ADDENDUM NO. TWO (2)

PEDESTRIAN ACCESS RAMP & CANOPY SYSTEMS
at the
CHARLOTTESVILLE-ALBEMARLE AIRPORT
CHARLOTTESVILLE, VIRGINIA

TBI Project No. 2215-1502A
IFB No. 2017-115

May 18, 2017

CONCRETE SIDEWALK JOINT LAYOUT

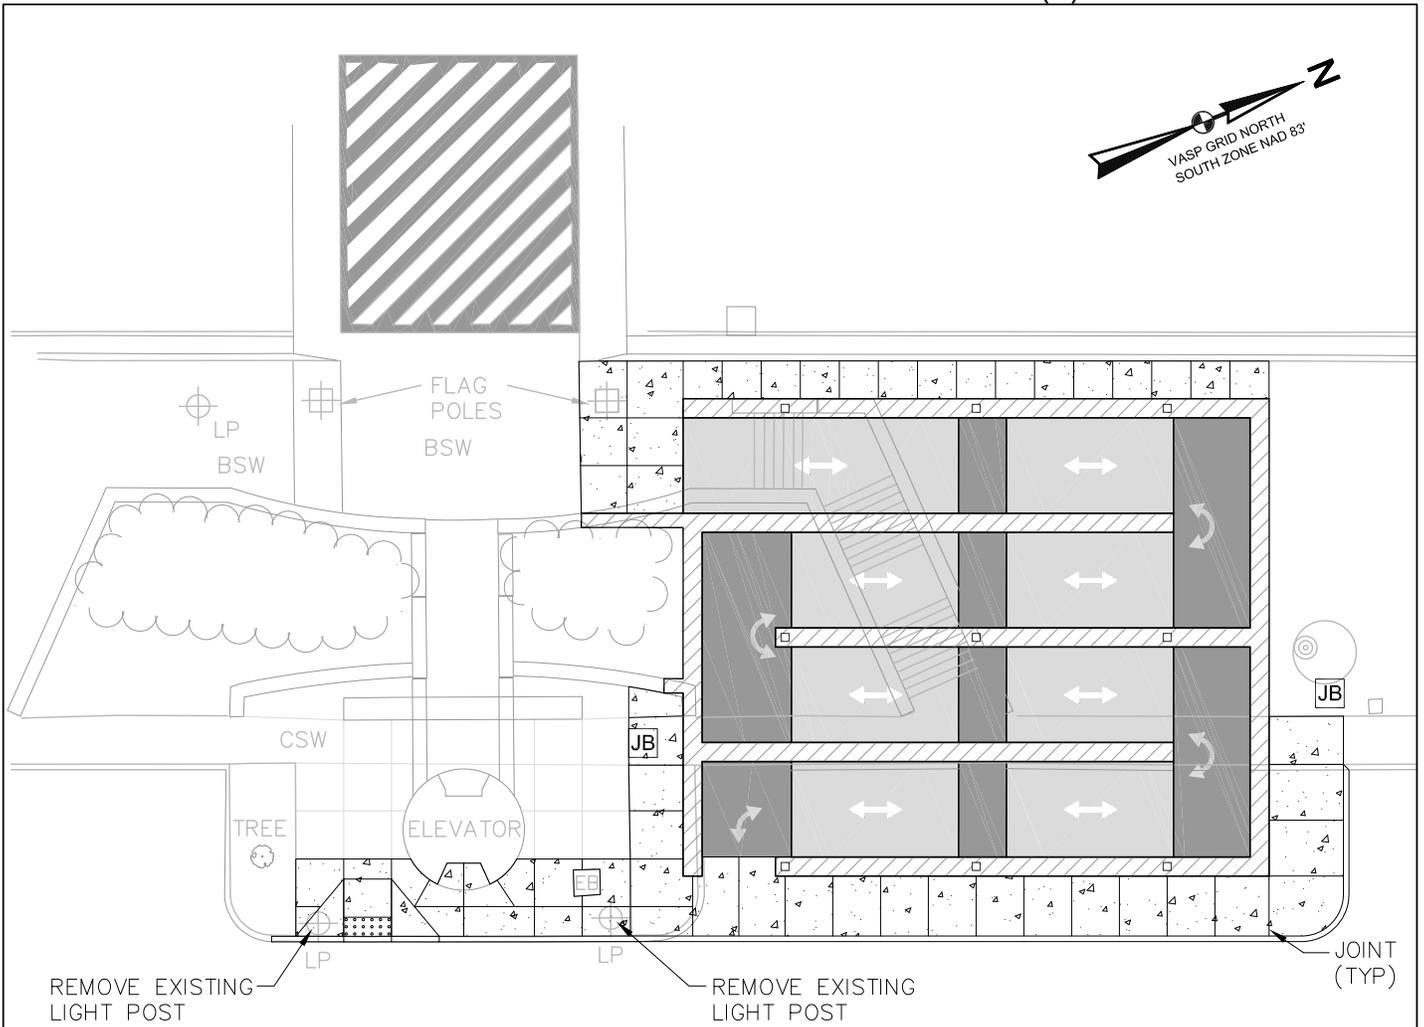
Replace the Concrete Sidewalk Joint Layout detail with the *Revised* Concrete Sidewalk Joint Layout detail included as Attachment “B” to this Addendum No. Two (2).

1. PROVIDE 1/2" EXPANSION JOINT BETWEEN PROPOSED SIDEWALK AND RETAINING WALL, BETWEEN PROPOSED SIDEWALK AND CURB, BETWEEN PROPOSED SIDEWALK AND ELEVATOR, AND AROUND ALL EXISTING AND PROPOSED STRUCTURES (LIGHT POLES, FLAG POLES, JUNCTION BOXES).
2. ALIGN JOINTS IN NEW CONCRETE WITH EXISTING JOINTS AROUND ELEVATOR.
3. ALIGN JOINTS IN NEW CURBING WITH JOINTS IN SIDEWALK.
4. PROVIDE 1/8" CRACK CONTROL JOINTS AT INTERVALS NOT TO EXCEED WIDTH OF THE SIDEWALK. PROVIDE 1/2" EXPANSION JOINT AT INTERVALS NOT TO EXCEED 50'.
5. REFERENCE SHEET 8 FOR SIDEWALK AND CURBING DETAILS AND ADDITIONAL NOTES.
6. REFERENCE SHEET S101 FOR RAMP CONCRETE WALKING SURFACE REQUIREMENTS.
7. SLOPE CONCRETE UP AT ELEVATOR SILL FOR POSITVE DRAINAGE AWAY FROM THE ELEVATOR.

ELEVATOR AREA LIGHTING LAYOUT

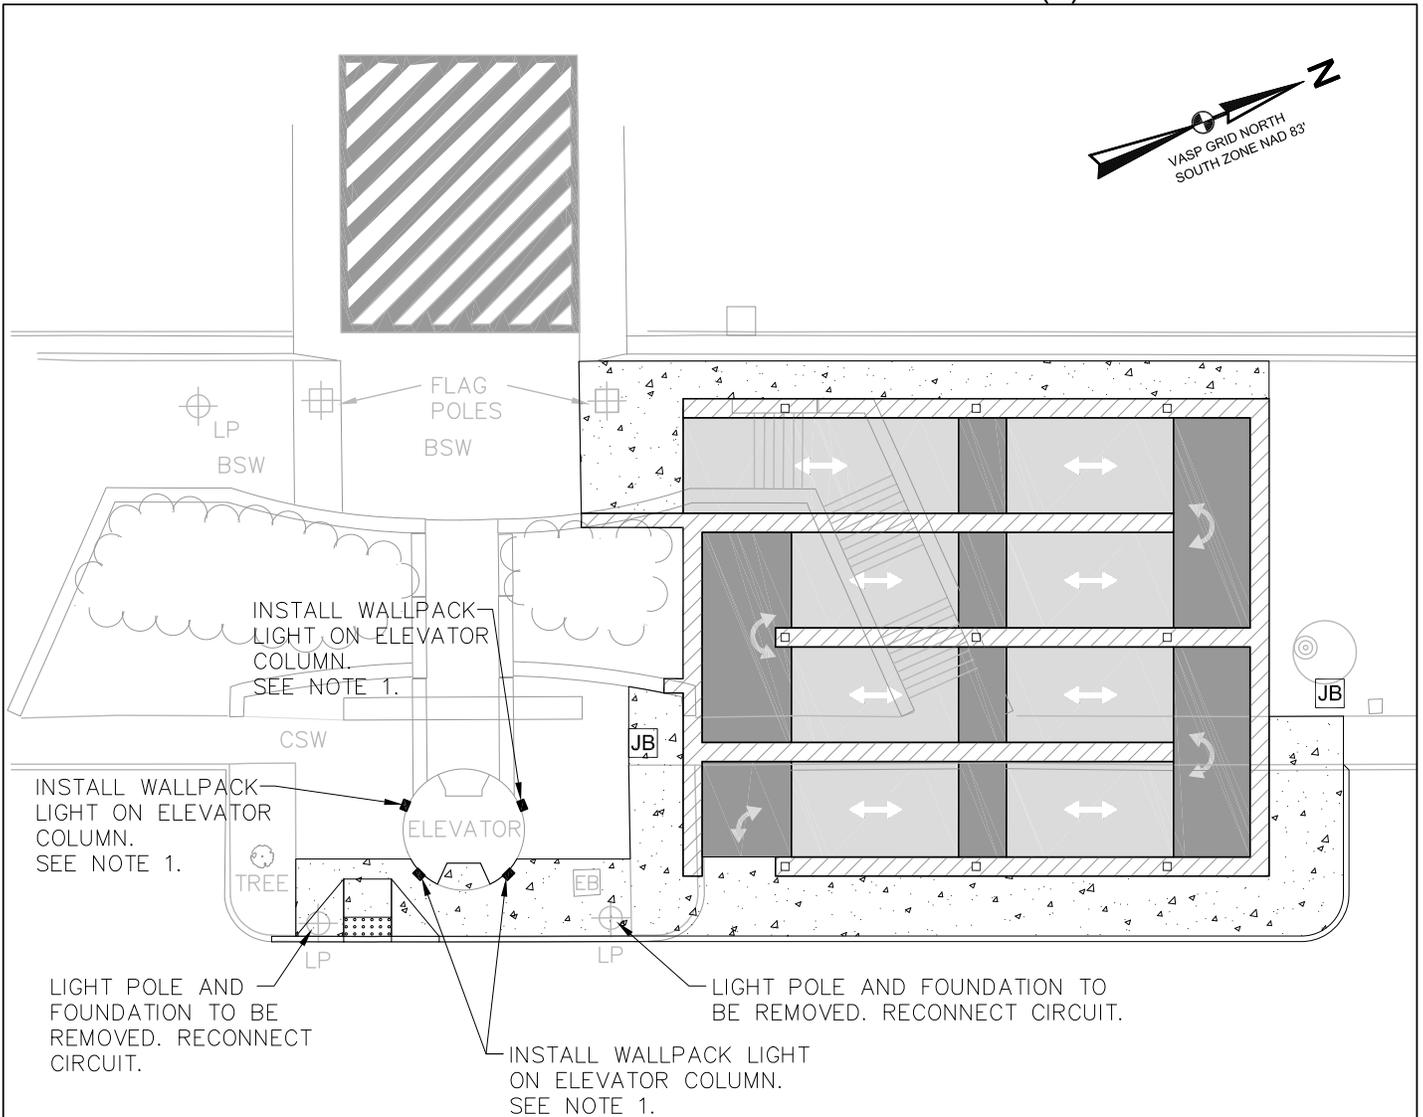
Add new detail Elevator Area Lighting Layout included as Attachment “C” to this Addendum No. Two (2).

1. INSTALL WALLPACK LIGHTS TO ELEVATOR COLUMN AT APPROXIMATE 9'-6" ABOVE GROUND HEIGHT, TOP OF FIXTURE TO BE IMMEDIATELY BELOW THE EXISTING RECESSED BRICK HEADER LINE. USE MASONRY BIT TO DRILL THROUGH MORTAR FOR ELECTRICAL SERVICE. FIELD LOCATE AND RUN WIRING FOR NEW LIGHTING.

2. POWER SOURCE IS THE ELEVATOR MECHANICAL ROOM , PANEL 'P1B'. TIE-IN TO EXISTING CIRCUIT #8 (EXTERIOR LIGHTING) OR PROVIDE NEW 20-AMP BREAKER FOR NEW SEPARATE CIRCUIT. ANY EXPOSED WIRING ON INTERIOR OF ELEVATOR COLUMN OR WITHIN MECHANICAL ROOM SHALL BE INSTALLED IN CONDUIT MOUNTED TO THE WALL.

3. PROVIDE 1 PHOTOCCELL TO CONTROL WALLPACK LIGHTS.
4. WALLPACK LIGHT FIXTURE TO BE HUBBELL OUTDOOR LIGHTING GEOPAK SERIES 1 LED, RDI1-12L-20-4K-3-U-BL, OR APPROVED EQUIVALENT.

5. APPLY SILICONE SEALANT AROUND LIGHT FIXTURE TO MOUNTING SURFACE TO PROVIDE WATERTIGHT SEAL.
6. INSTALLATION OF WALLPACK LIGHTS MAY REQUIRE TEMPORARY DISRUPTION OF ELEVATOR SERVICE. COORDINATE WITH AIRPORT MANAGEMENT FOR APPROVED TIMING OF THIS WORK.

ADDENDUM NO. TWO (2)
ATTACHMENT "D"

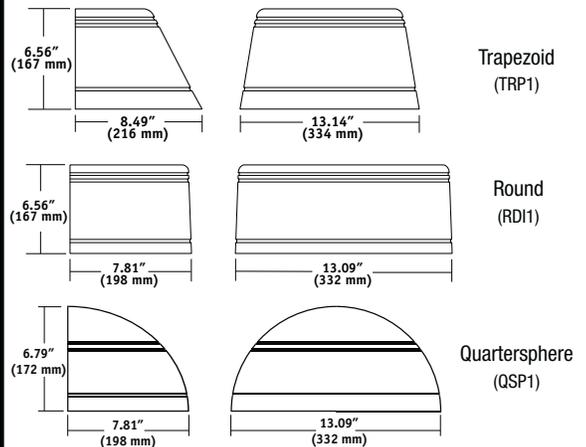
Add the Wall Pack Light Detail included as Attachment “D” to this Addendum No. Two (2). The wall pack light fixture shall be Hubbell Outdoor Lighting Geopak Series 1 LED, RDI1-12L-20-4K-3-U-BL, or approved equivalent.
